**▼B****COMMISSION IMPLEMENTING REGULATION (EU) 2021/1228****of 16 July 2021****amending Implementing Regulation (EU) 2016/799 as regards the requirements for the construction, testing, installation, operation and repair of smart tachographs and their components****(Text with EEA relevance)***Article 1*

Annex IC to Implementing Regulation (EU) 2016/799 is amended as follows:

*Figure 2*  
**VU error handling**

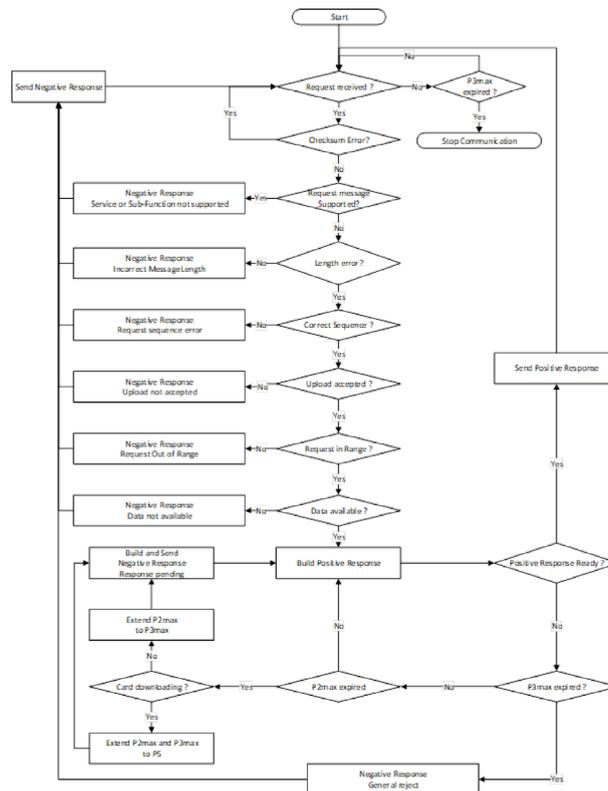
(iv) in point 2.2.5.2, Figure 2 is replaced by the following:
